**Re: FortisBC Inc. Application for a Certificate of Public Convenience and Necessity for the Advanced Metering Infrastructure Project ~ Project No. 3698682**

Commercial Energy Consumers Association of BC

Information Request # 1

For Girish Kumar, B.Sc. PhD (Electrical Engineering)

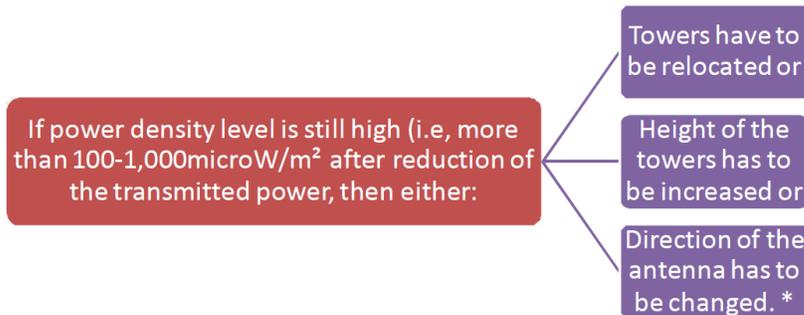
19.1. Please compare the power from the carriers to North American standards for carriers

19.2. Please confirm that North American carriers operate at powers in the range proposed.

- 19.3. Please describe how to remove power amplification and reduce the gain of the antenna (or amplifier if this is correct).
- 19.4. Please discuss why telecom carriers in India have lower towers and use more power in their communication signals than is done in North America.
- 19.5. Please discuss the ability of the telecom industry in India to make the additional investments to increase the number of communication towers, increase the height of the towers and change the direction of the antennas.
